<Topcon Positioning Systems, Inc.>

Declaration of Product Modifications

This is to request a Class II permissive change for FCC ID:WR4-CRS2 originally granted on 12/19/2025.

Old
schematic diagram
FCC ID:WR4-CRS2

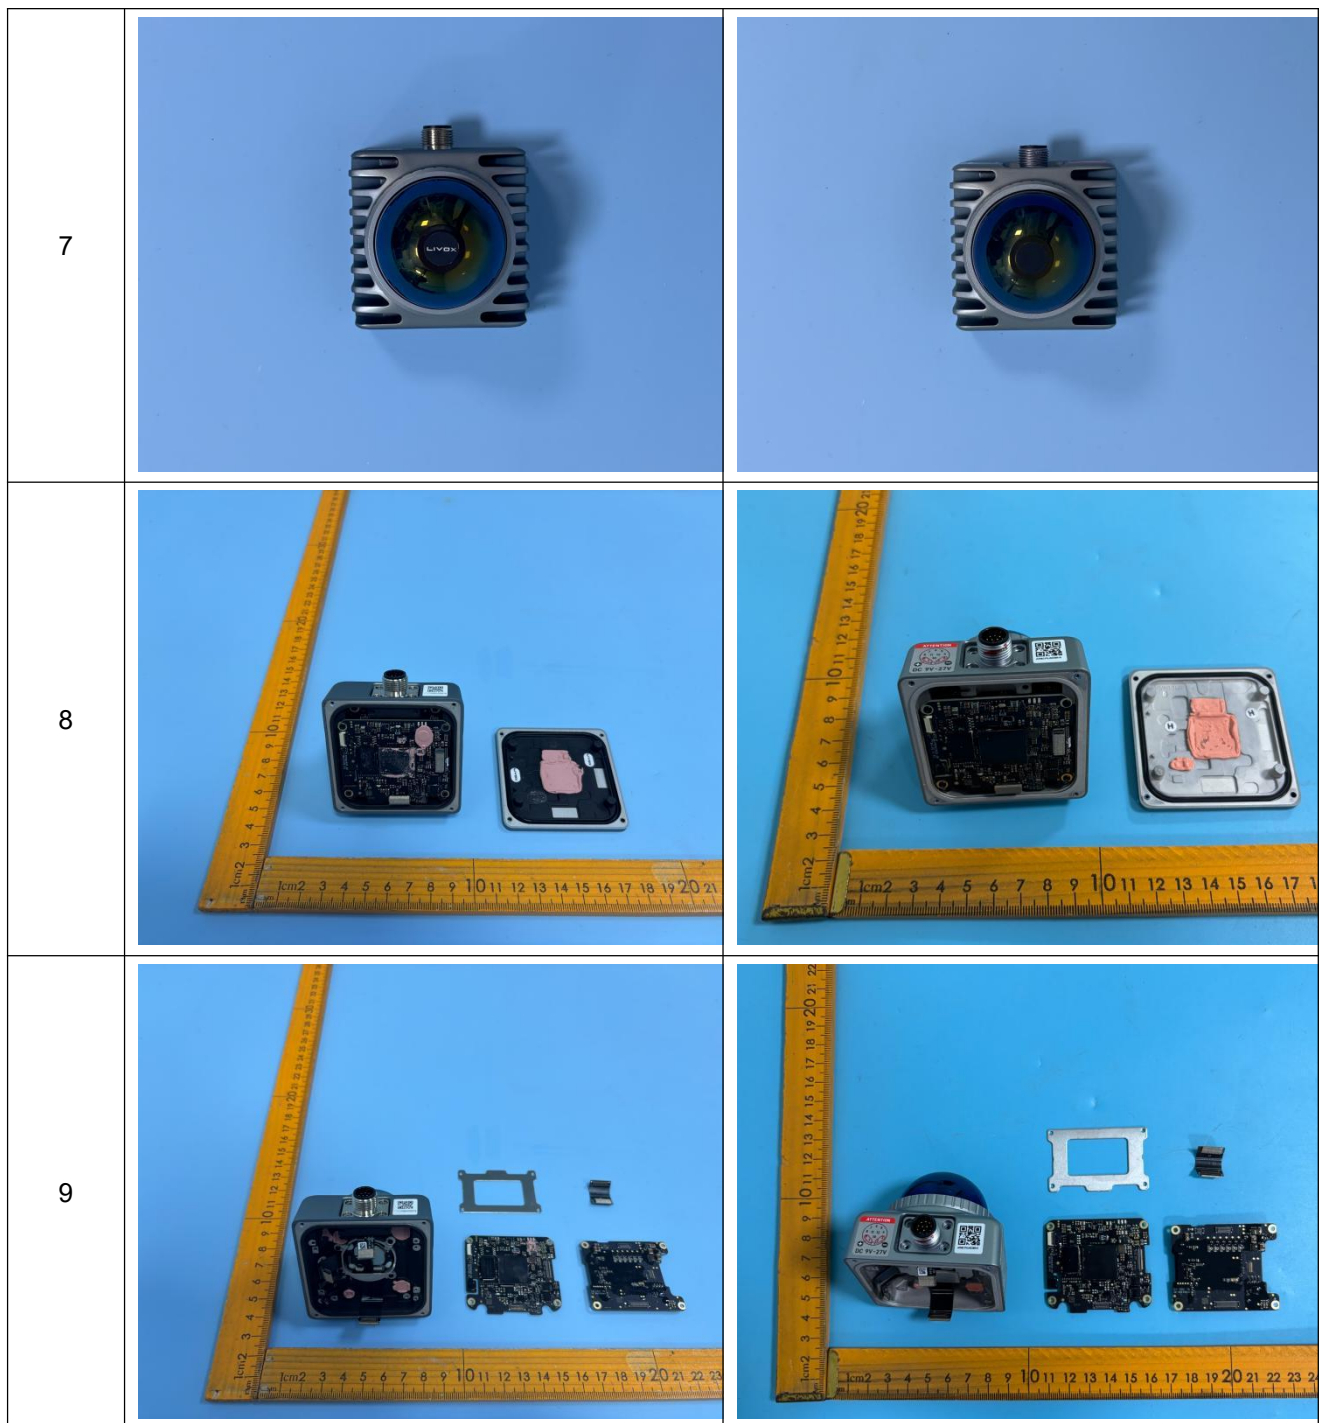
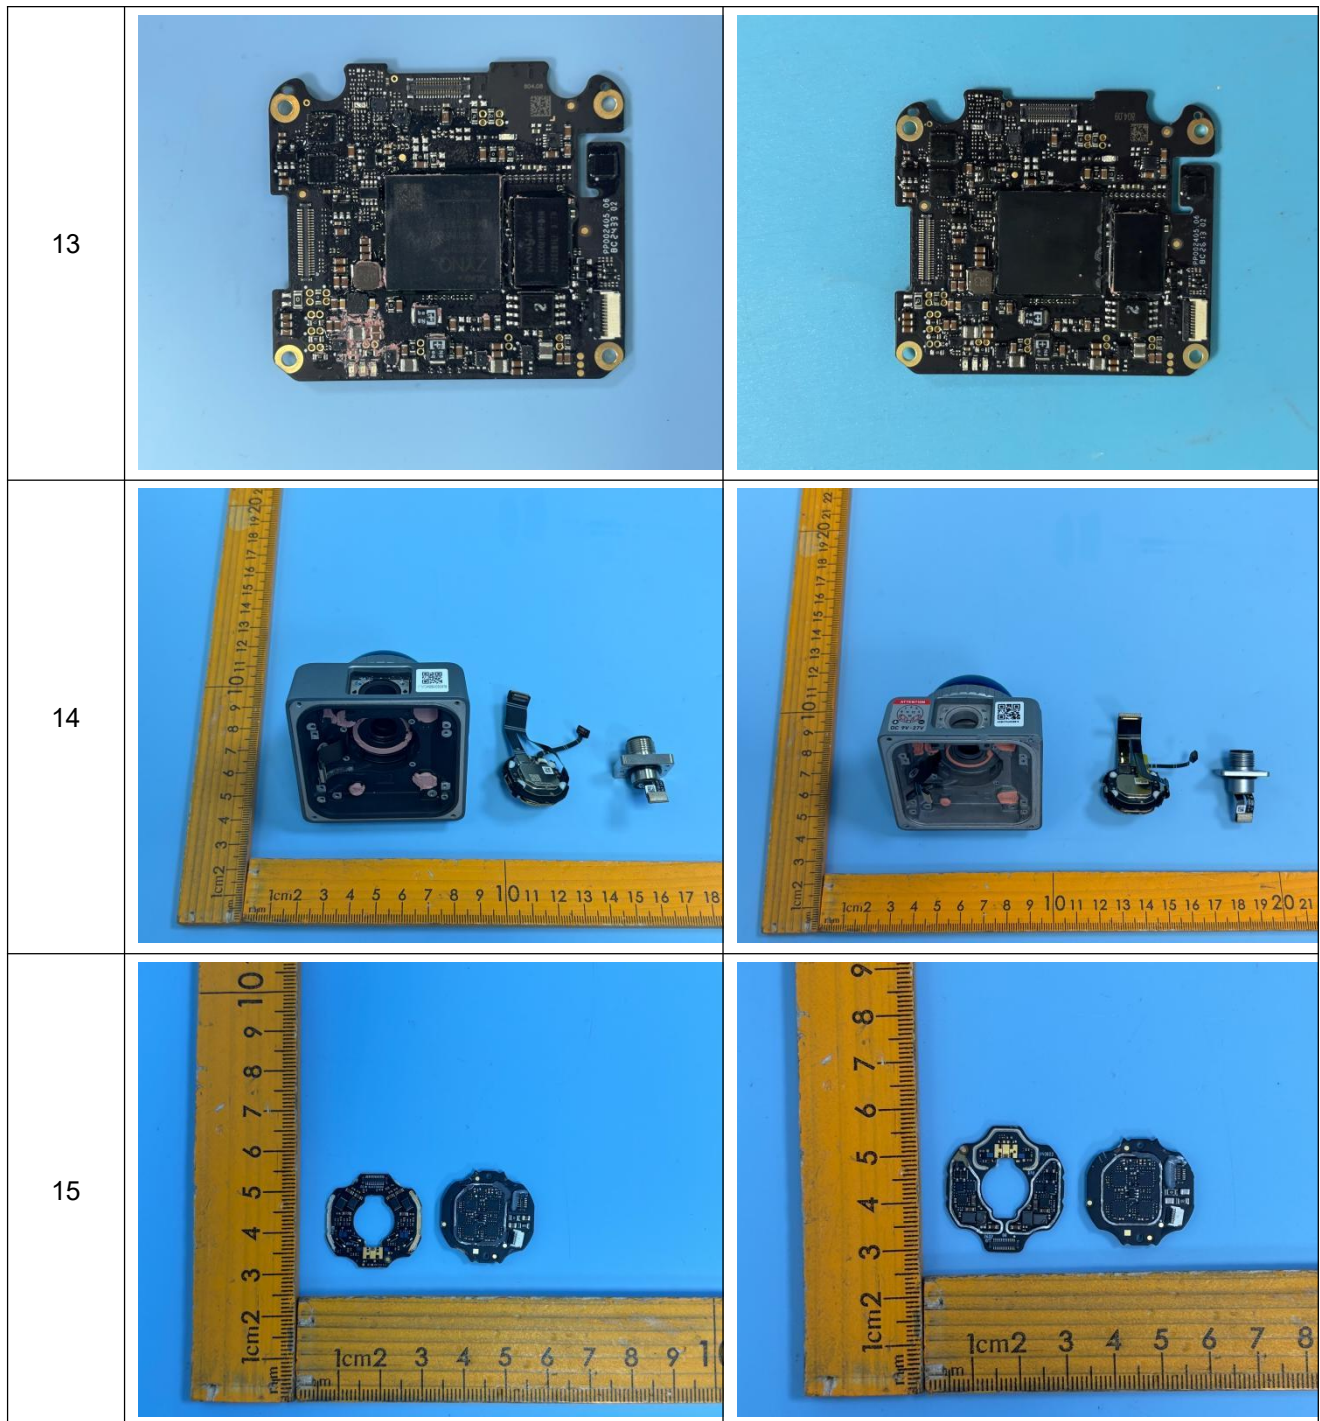
We demonstrate that the device's RF module is consistent with the old report, The hardware circuit of the laser module has changed, but it does not affect the RF circuit, and the only difference is that the laser has changed from MID-360 to MID-360S. The position of the laser hardware PCB board and the housing aviation plug has slightly changed. This will affect the test results. A low-frequency 30MHz-1GHz difference test was conducted, and other test data are referenced from the original report. Please refer to the attachment for specific differences.
